Change Order

Williamson County
Animal Shelter Expansion
1855 SE Inner Loop
Georgetown, TX 78626

Change Order Number: 006

Change Order No. 6 includes the below listed Vaughn Change Proposals # 27-#31. For Vaughn Project No. 2491-01.

ARCHITECT: JACKSON & RYAN ARCHITECTS	
PROJECT: WILLIAMSON COUNTY REGIONAL ANIMAL SHELTER	JOB NUMBER: 16042
Date: 06/18/2018 Drawn by: KN Check by: CM	Revision: RFI-053 Drawing No. SK-01

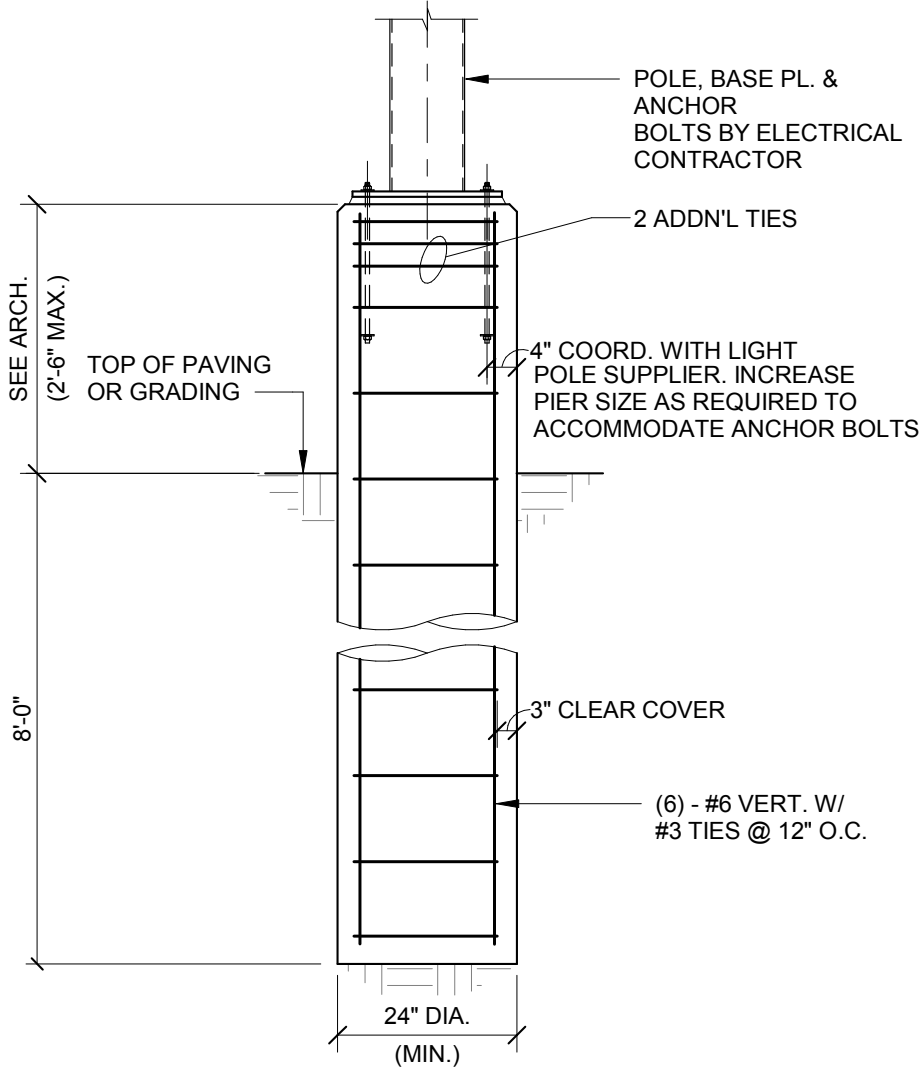
Re: Lighting pole reinforcement and locations

- 1) Civil page 13 shows the lighting pole detail but has no information on the reinforcement for the base
- 2) Please verify the locations of the lighting poles

See attached sketch 'SK-01' which issues new detail 11/S3.05 for the typical site light pole foundation.

1. CONCRETE SHALL HAVE A 28 DAY COMPRESSIVE STRENGTH OF 3000 PSI WITH A MAXIMUM AGGREGATE SIZE OF 3/4" AND A MAXIMUM WATER / CEMENT RATIO OF 0.54.
2. ALL REINFORCEMENT SHALL CONFORM TO ASTM A615, GR. 60.
3. ASSUMPTIONS FOR FOUNDATION DESIGN INCLUDE A 5", 25 FT. POLE W/ FIXTURES AND A MAXIMUM EQUIV. PROJECTED AREA OF 5 SQ. FT.
4. SEE ELECTRICAL DRAWINGS AND SPECIFICATIONS FOR ADDITIONAL INFORMATION AND REQUIREMENTS.
